# Access Compliance Report

## Public Rights-of-Way (Curb Ramps)

Intersection ID: 42780	Main Street: SILVERSWORD_DR	Cross Street: PURPLE_DAWN_DR	Location: SE
ADA ID: BA8DFD277CBB	Ramp Type: PerpDiag	Initial Pass/Fail: Fail	Overall Compliance: No
Severity Score: 46.25			
Codes/Mitigation Info/Possible Solution		Field Measurements/Component Compliance

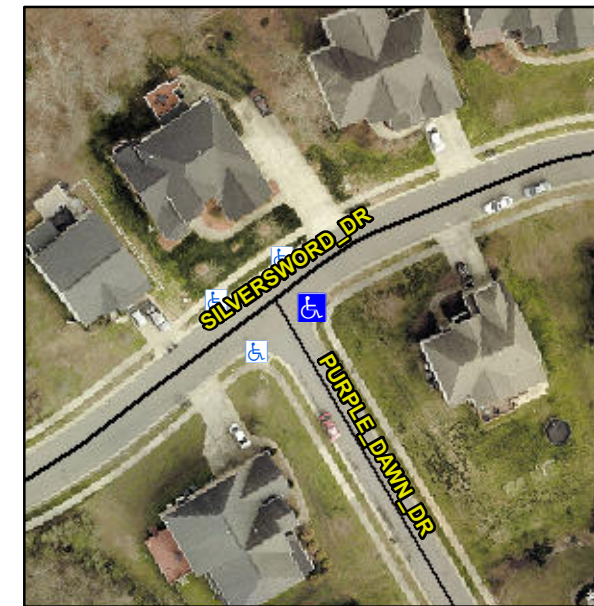
**Not Found, R304.5.1, R304.2.2, R304.5.3**

Compliance	Description	Data	Compliance	Description	Data
N/A	Ramp Length (in)	49.0	No	Ramp Slope (%)	10.2
No	Ramp Width (in)	44.5	No	Ramp XSlope (%)	9.6
N/A	Flare Type LT	N/A	N/A	Flare Type RT	N/A
N/A	Flare Slope LT (%)	N/A	N/A	Flare Slope RT (%)	N/A
N/A	Flare Traversable LT?	N/A	N/A	Flare Traversable RT?	N/A
N/A	Landing Length (in)	N/A	N/A	DWS Provided?	N/A
N/A	Landing Width (in)	N/A	N/A	DWS Contrast?	N/A
N/A	Landing Slope (%)	N/A	N/A	DWS Length (in)	N/A
N/A	Landing X Slope (%)	N/A	N/A	DWS Full Width?	N/A
N/A	Landing Curb? (Y/N)	N/A	N/A	DWS Offset (in)	N/A
N/A	Shared Landing?	N/A			
N/A	Gutter Ponding?	N/A	N/A	Gutter Slope (%)	N/A
N/A	Gutter Lip Ht (in)	N/A	N/A	Gutter X Slope (%)	N/A
N/A	Painted X Walk1?	No	N/A	Painted X Walk2?	No
	X Walk 1 Direction	To NW		X Walk 2 Direction	To SW
N/A	X Walk 1 Width (in)	N/A	N/A	X Walk 2 Width (in)	N/A
	X Walk 1 Slope (%)	2.0		X Walk 2 Slope (%)	3.1
	X Walk 1 X Slope (%)	5.5		X Walk 2 X Slope (%)	5.6

**Remove & Replace Curb Ramp With Two New Directional Ramps or Equivalent.**
